## Oconee Nuclear Station

Duke Energy Presentation to the NRC Committee to Review Generic Requirements (CRGR) – October 24, 2017

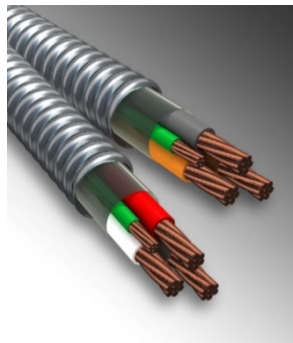
- Separation is accomplished through the use of distance and/or barriers. Information on cable routes, separation distances, cable construction (including armor), and barriers has been contained within Oconee FSAR Chapters 7 & 8 since initial licensing.
- Oconee SERs for initial licensing document that the provisions for installation and separation of cables were reviewed and found to be acceptable.
- In addition to the Oconee FSAR content, Oconee correspondence to the AEC on 12/22/1970 described the philosophy around the use of armored cable. The Duke Energy design incorporates cable armor to serve as a protective barrier that acts in much the same manner as flexible conduit. Essentially, each cable has its own conduit “built-in” by the armor.

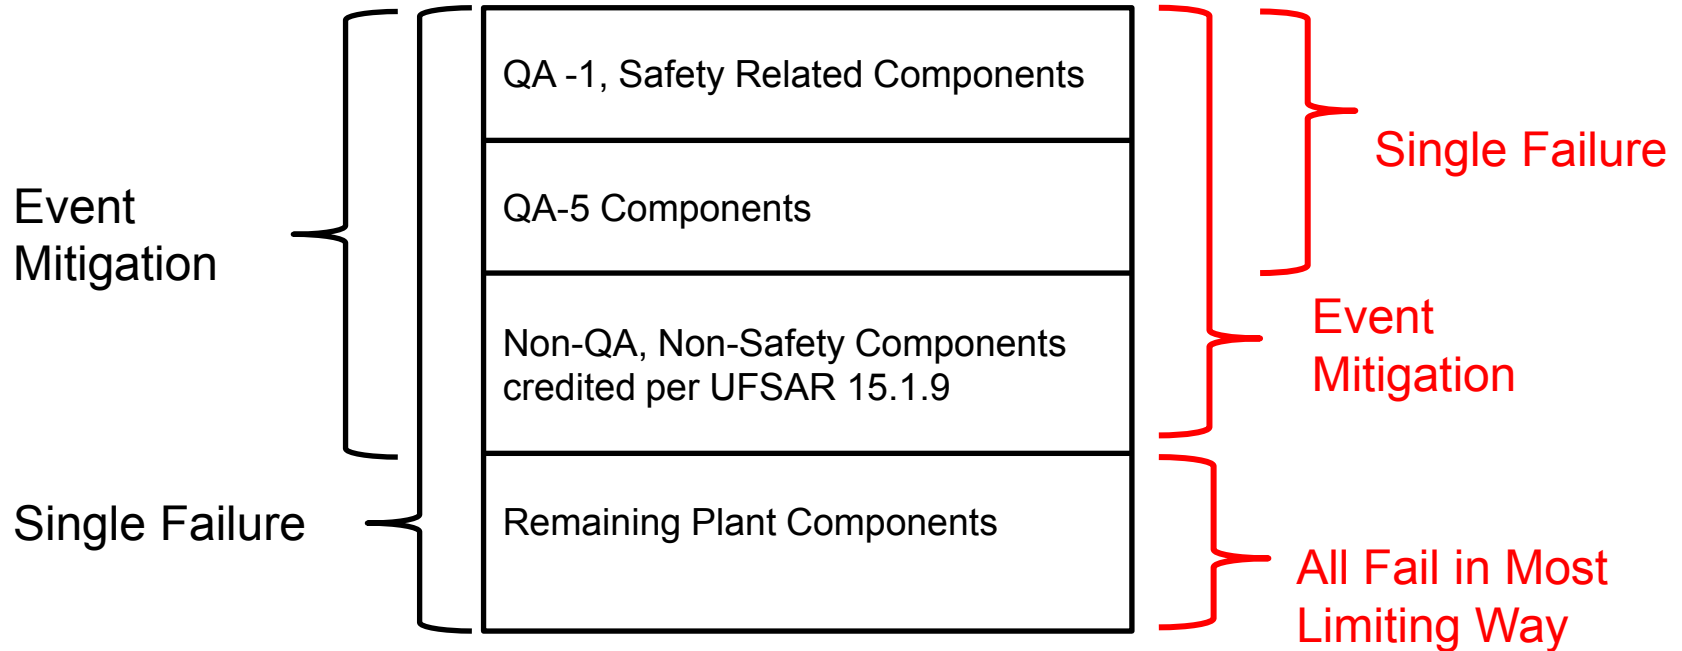
- The requirement to consider the failure in the most limiting way of all Non-QA equipment coincident with one single failure of Class 1E equipment is not supported by Oconee's licensing basis for single failure analysis.
